CALIFORNIA DIVISION OF MINES AND GEOLOGY
FAULT EVALUATION REPORT FER-245
SUPPLEMENT No.1

**SILVER STRAND FAULT, CORONADO FAULT, SPANISH BIGHT FAULT,
SAN DIEGO FAULT and DOWNTOWN GRABEN**
Southern Rose Canyon Fault Zone
San Diego, California

by
Jerome A. Treiman
April 22, 2003

Figure 1 (FER-245, supplement no.1)

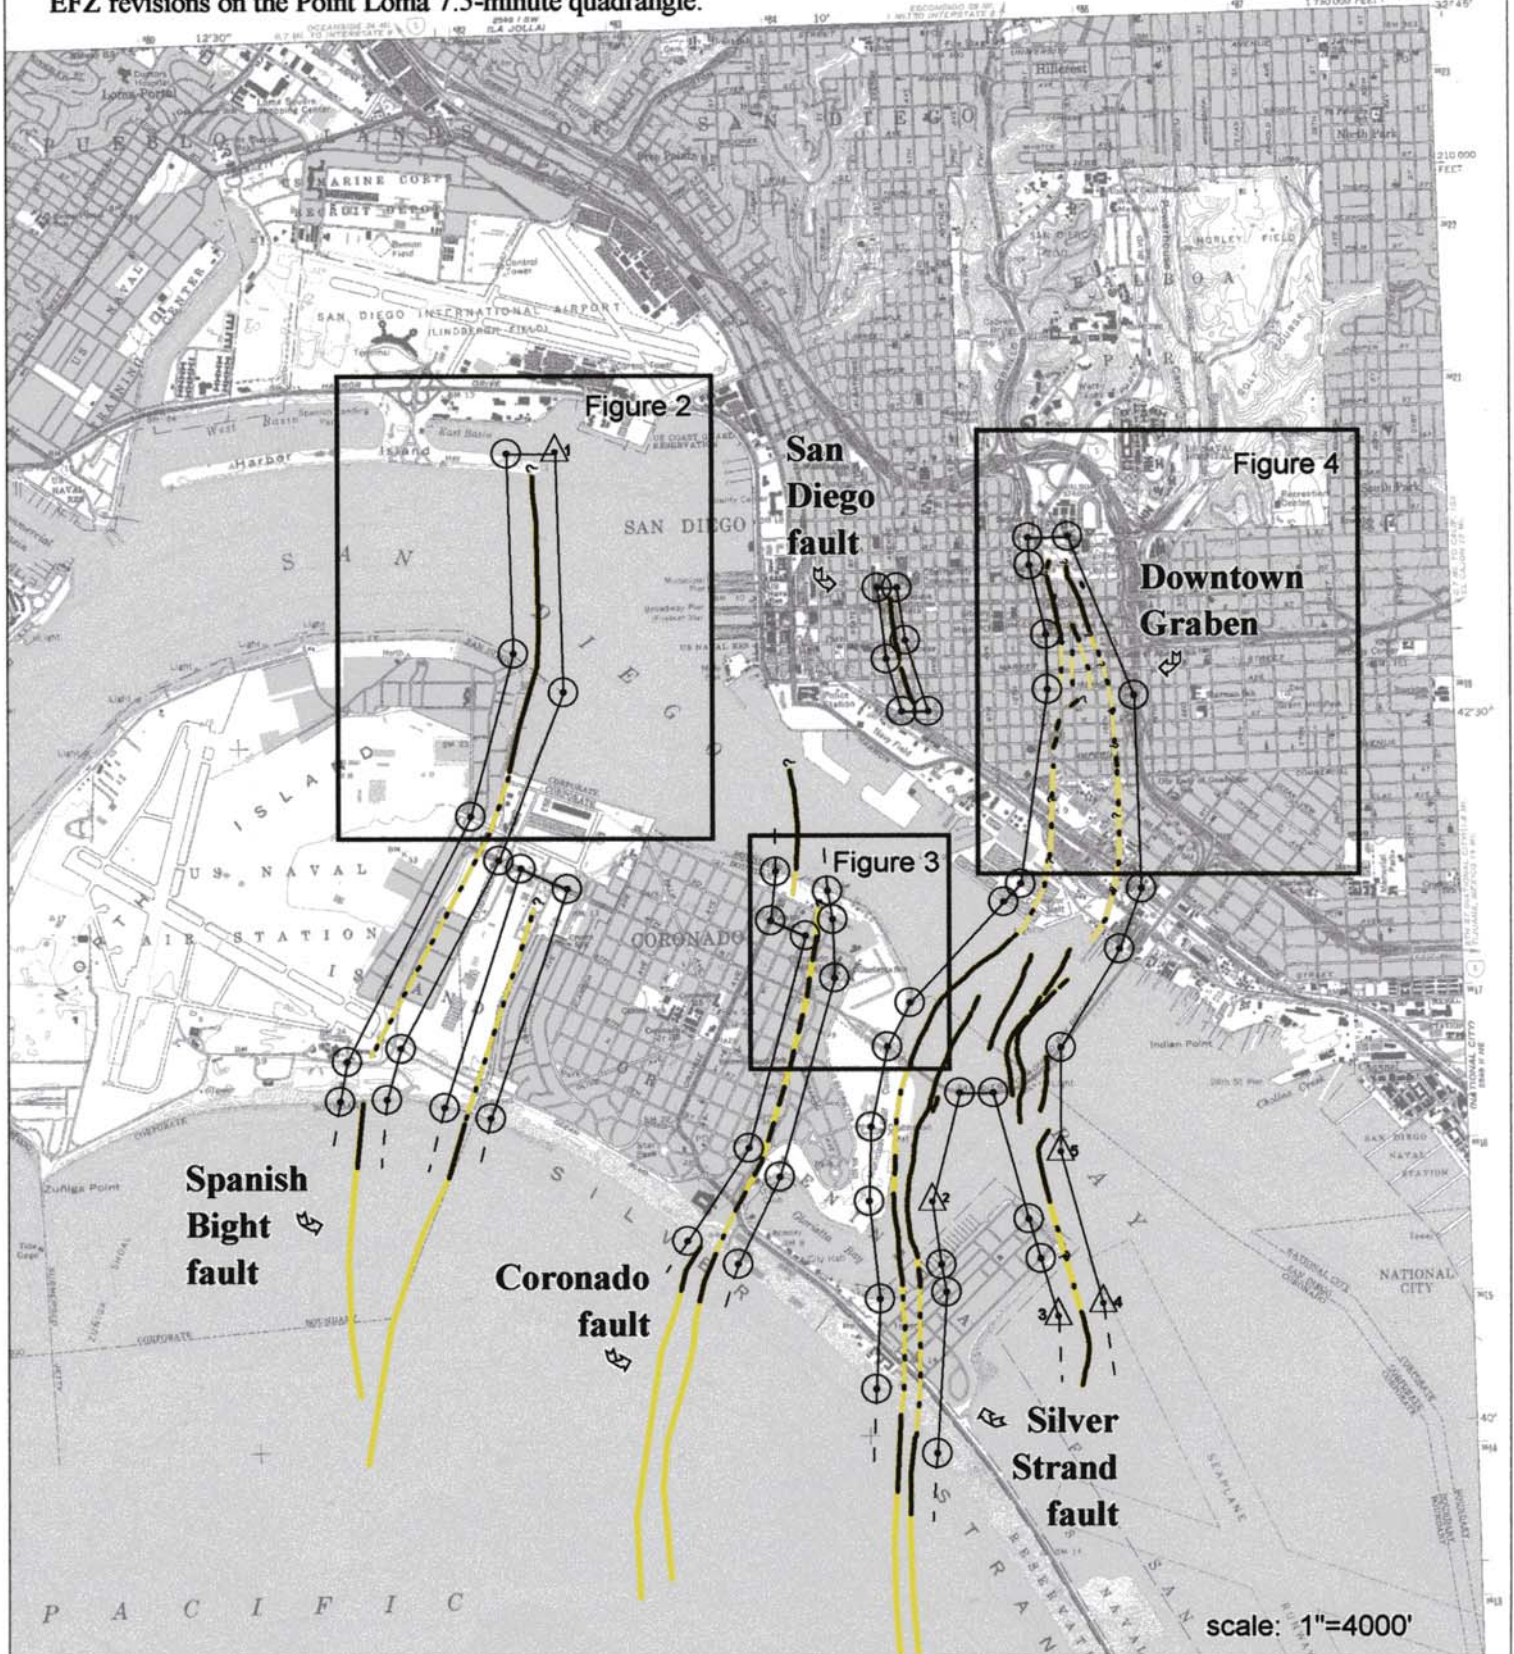
The purpose of this supplement is to respond to comments received during the official review period for the proposed Earthquake Fault Zone revisions recommended in Fault Evaluation Report 245 (Treiman, 2002) and portrayed on the Preliminary Review map of the Point Loma quadrangle released on November 1, 2002. Relevant to this proposed zoning, we received three communications through the State Mining and Geology Board, as summarized on Table 1. In addition we received one further communication from the Port of San Diego (copy attached as Appendix A) and a report by Robert Prater Associates (2000) regarding a small fault in the downtown graben. Affected areas are indexed on Figure 1.

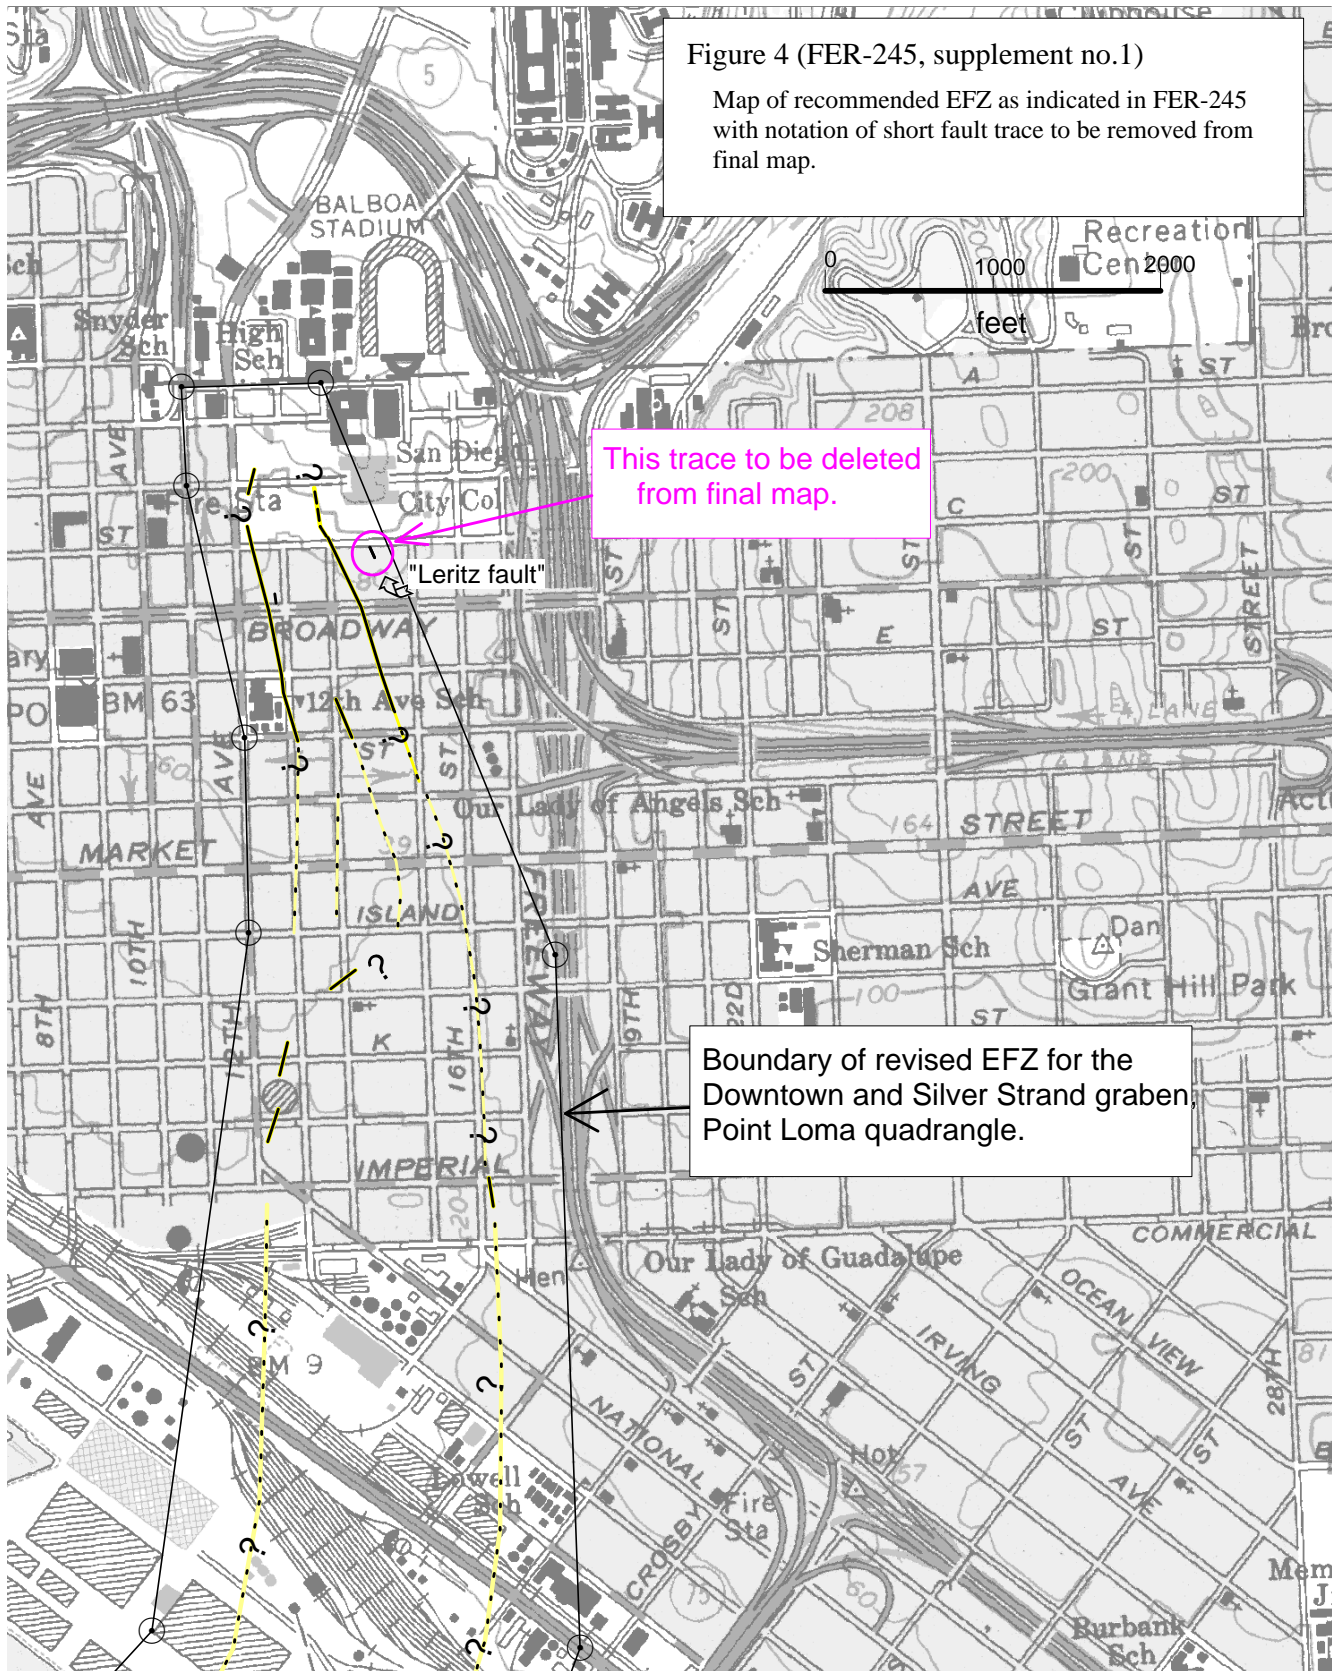
A report by Robert Prater Associates (2000) was sent to us by Geocon, Inc. with a request that the small fault (informally referred to as the Leritz fault by Prater Associates) be deleted from the Official EFZ map. The report provides evidence that the Leritz fault south of C Street, near 15th (see figure 4) is not active. This short fault trace had previously been reported as possibly active, based on preliminary studies by consultants (W. Landry, personal communication, July 1999). Prater Associates excavated 5 trenches across the Leritz fault and exposed a west-dipping normal fault that offsets Plio-Pleistocene San Diego Formation and overlying Pleistocene terrace deposits. Trenches 1A and 1B exposed a well-developed argillic B soil horizon (their S₃ unit) that is clearly not offset by the Leritz fault. They estimated the age of the S₃ unit to be between 53 ka and 156 ka, based on soil profile development. Based on the recently submitted data I **recommend that the short fault trace indicated on Figure 4 be removed from the zone map, but there should be no change to the EFZ boundaries.**
